Jefferson Proving Ground Madison, Indiana

Draft Final Phase II Remedial Investigation

Re: Draft Final Remedial Investigation
Jefferson Proving Ground,
Madison, IN

Figure 2-10. Soils Map

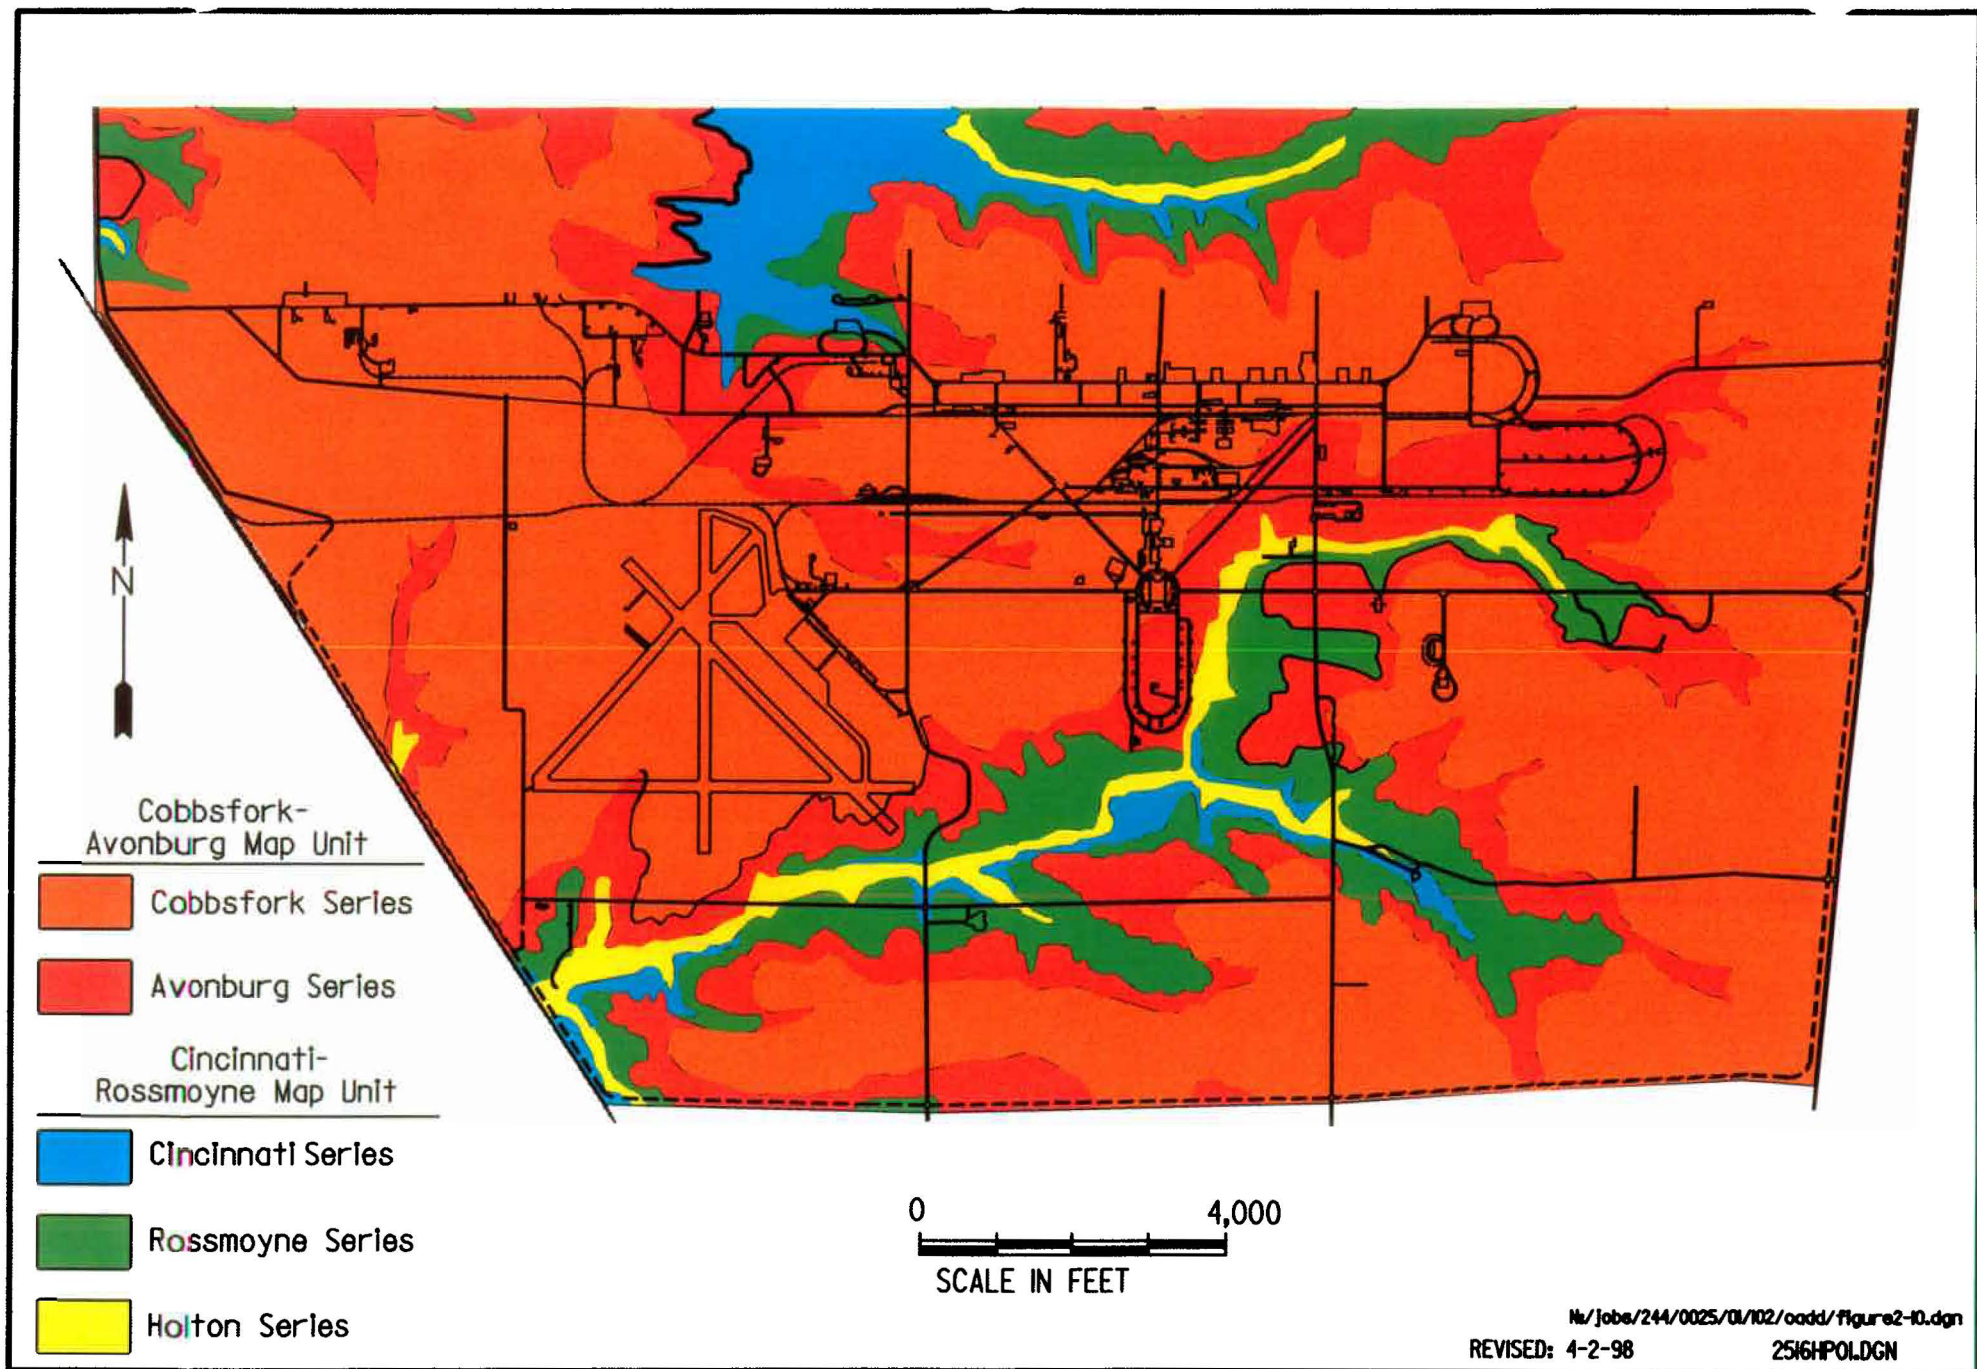
| Comment # | Section | EPA 31 May 2002 Comment | Army Response Submitted 21 June 2002 | EPA Evaluation of Response | Resolved (yes/no) |
|-------------------------|---------------|---|---|----------------------------|--------------------|
| EPA 3 | Sec 2.4 | Soils: Figure 2.10, does not provide information, it is unreadable. | These figures were intended to be included as color figures, however your copy of the Draft Final RI inadvertently included black and white copies. We apologize for this and the color copies are included for replacement. | | Yes – Sent 6/21/02 |

Figure 2-16. Groundwater Flow Direction, November 1995

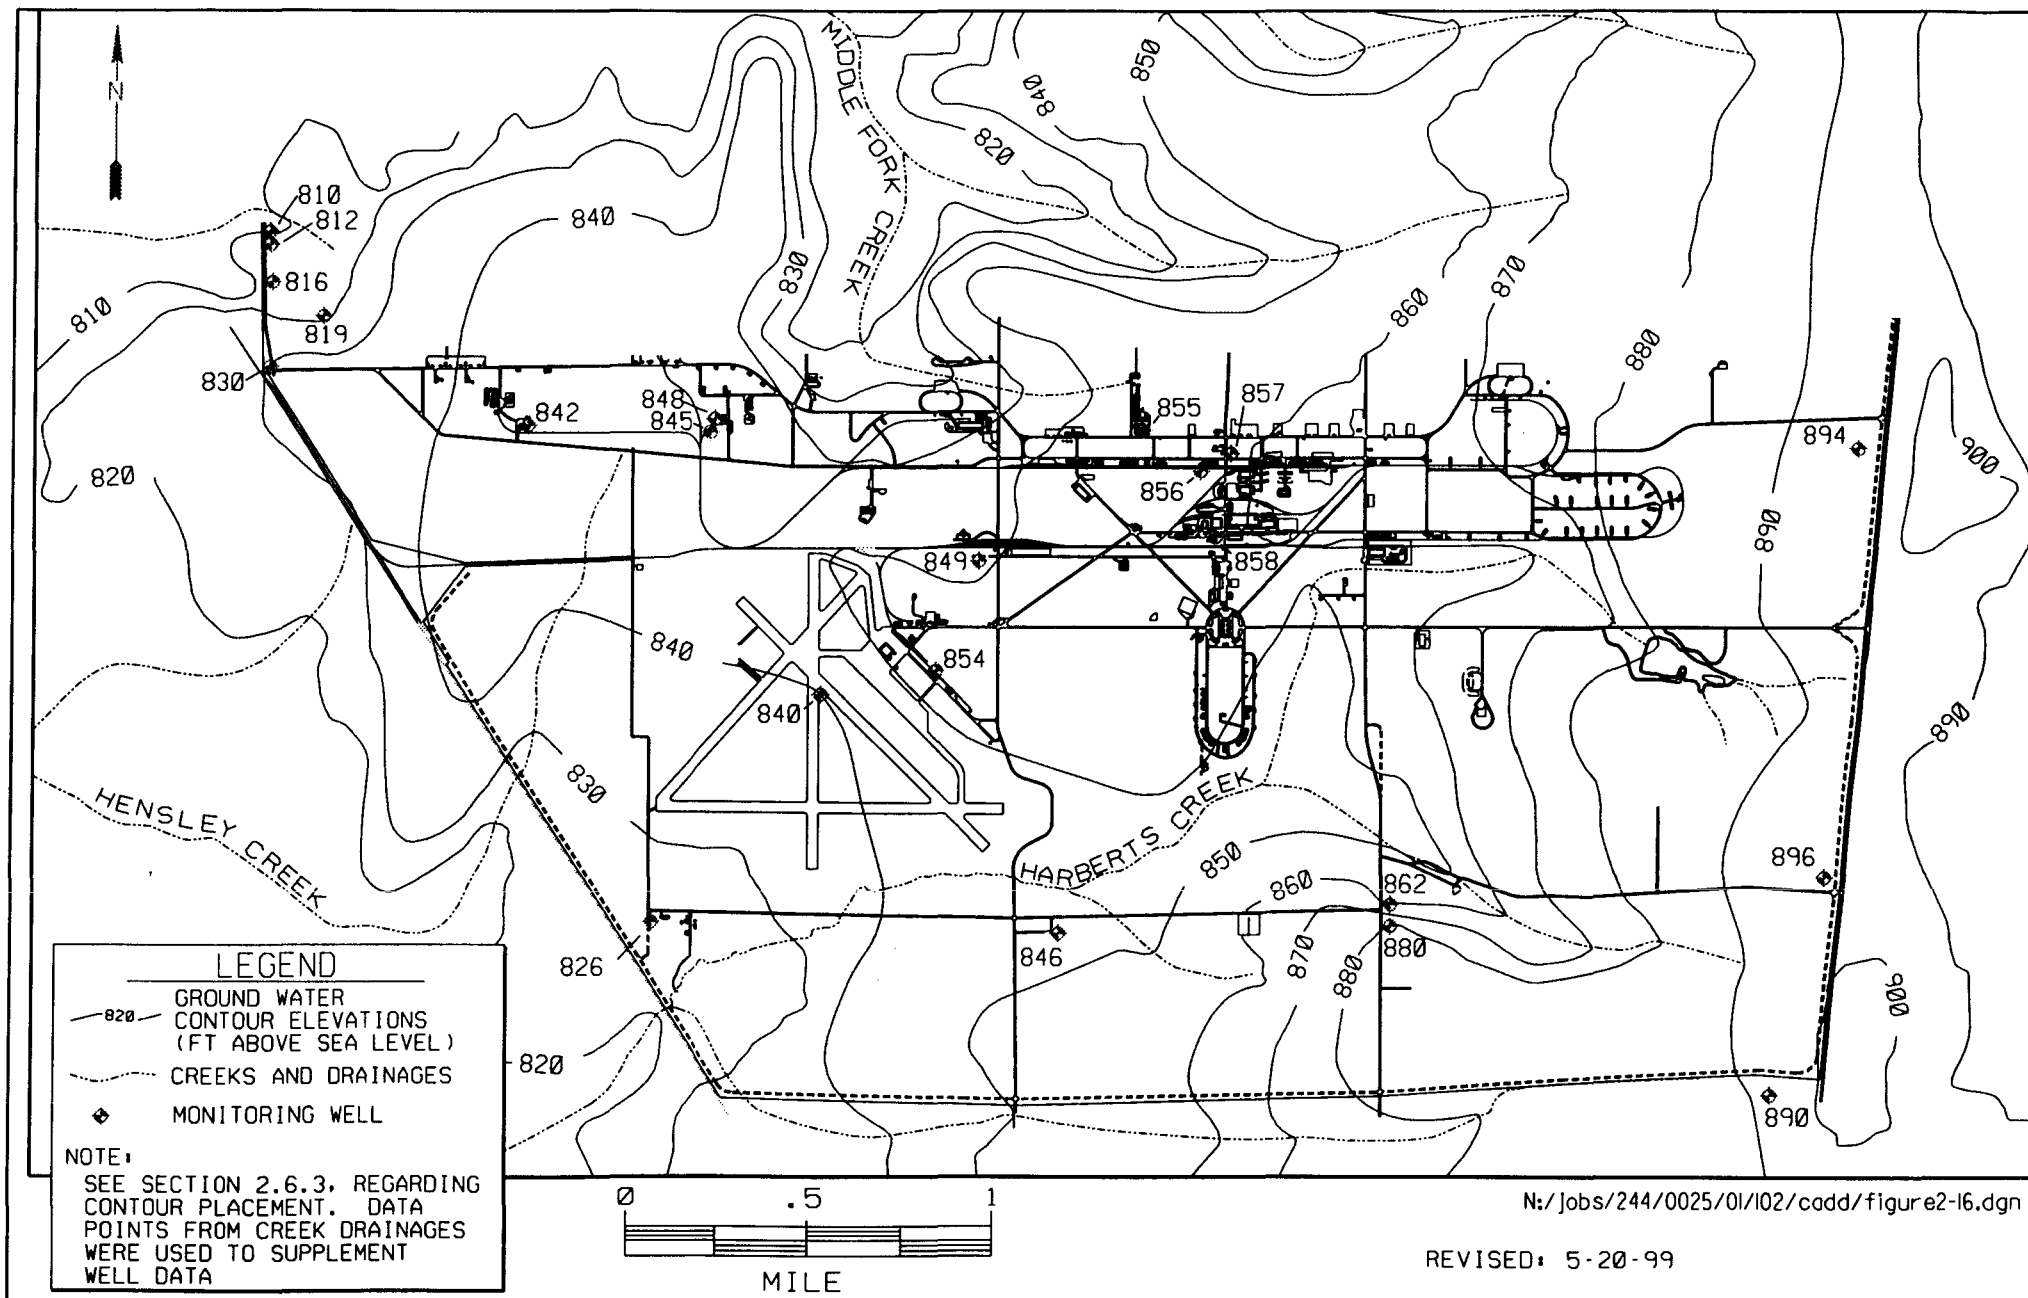
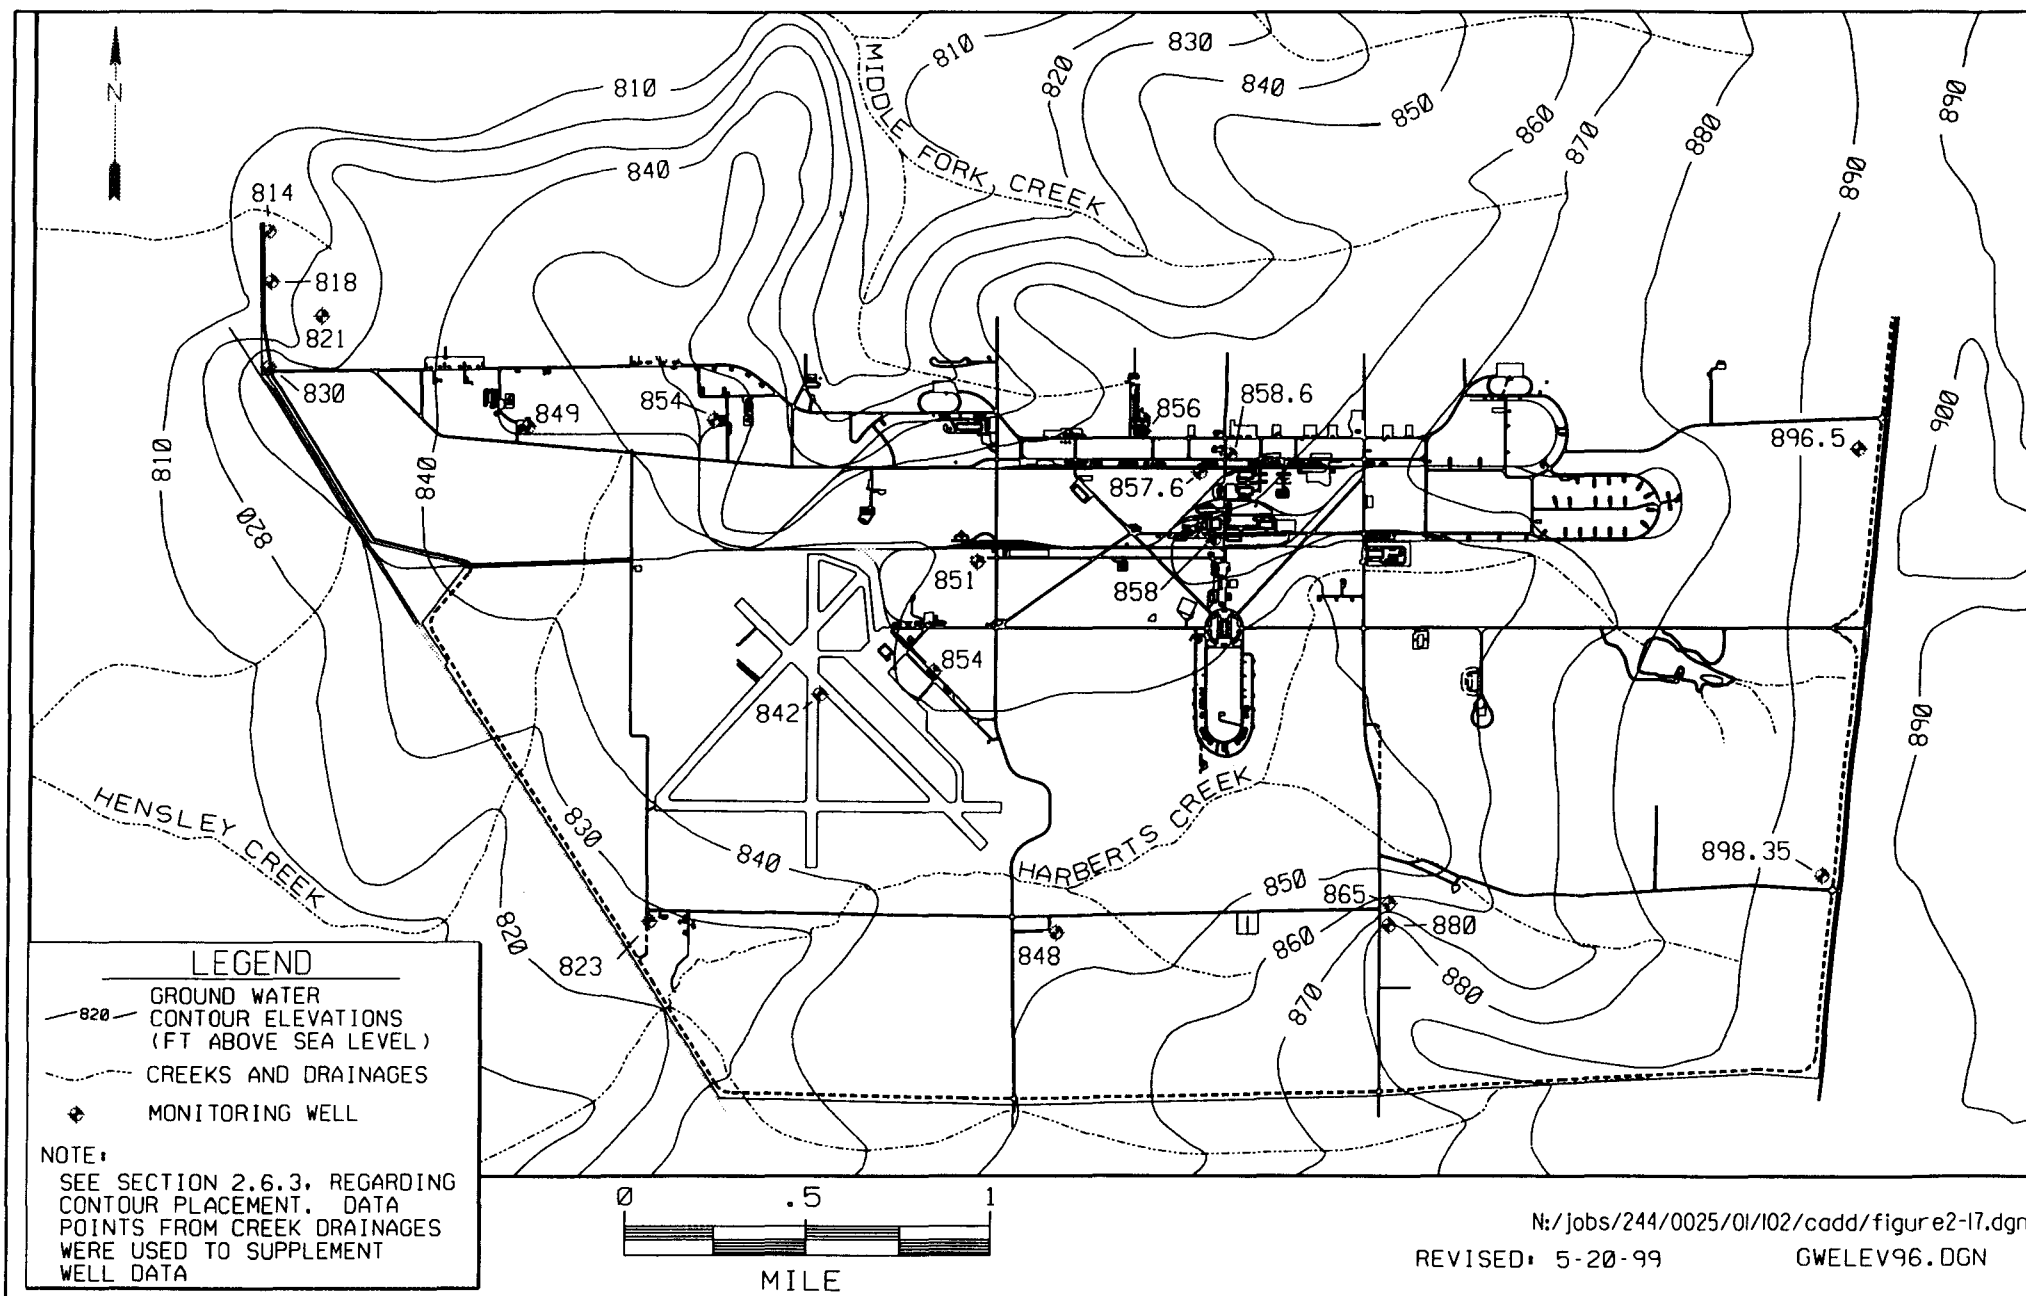
| Comment # | Section | Comment (EPA/IDEM as indicated in comment number) | Original Response to Comment (ET) | MW Revised Response (if applicable) | Agency Concur |
|-----------|--------------------|---|--|---|---------------|
| EPA28 | 02.6.3 | 2. Section 2.6.3, Groundwater Flow Characteristics, Figures 2-16 and 2-17: These figures present detailed contours, but only show a limited number of wells across the site. It is unclear if surface water features such as creeks or additional well measurements were used to better define the contours presented. If this is the case, it should be stated in the text and measurements presented on the figures, if possible. If not, the figures should depict areas of uncertainty accordingly. | Section 2.6.3, page 2-47, 2nd paragraph, describes how topographic data points were used in addition to monitoring well data to guide the placement of contours. Where there is uncertainty in the contours, dashed lines will replace solid lines. The note referring to Section 2.6.3 will be expanded to read: “See Section 2.6.3 regarding contour placement. Data points from creek drainages were used to supplement well data.” | Comment addressed per ET’s response. | |

| Comment # | Section | IDEM 30 May 2002 Comment | Army Response Submitted 21 June 2002 | IDEM Evaluation of Response | Resolved (yes/no) |
|-----------|---------------|--|--|-----------------------------|-------------------|
| IDEM 7 | Sec 3 | Figures 2-16 and 2-17: These maps are suppose to identify groundwater flow direction on two separate sampling events, however, there are no arrows present to show the flow direction being illustrated or discussed in the text in the section. | Groundwater flows from points of high to low equipotentials. Although the regional groundwater flow direction is from east to west, the local groundwater flow directions range through all compass directions. Therefore, to avoid confusion, arrows indicating groundwater flow directions have not been placed on these drawings; however, groundwater flow at any location is perpendicular to the equipotential contours moving from high to low equipotentials. A note to this affect will be added to the figures. | | Yes |

| Comment # | Section | IDEM 30 May 2002 Comment | Army Response Submitted 21 June 2002 | IDEM Evaluation of Response | Resolved (yes/no) |
|-----------|--|---|---|---|-------------------|
| IDEM 29 | Sec 13.1.1.2 | The text refers to Figures 2-16 and 2-17 as illustrating regional groundwater flow to the southwest in the bedrock system. However, these figures lack any identifying markings that show regional groundwater flow. IDEM staff request this information be added to the figures. | Refer to response to Specific Comment 7. | | Yes |
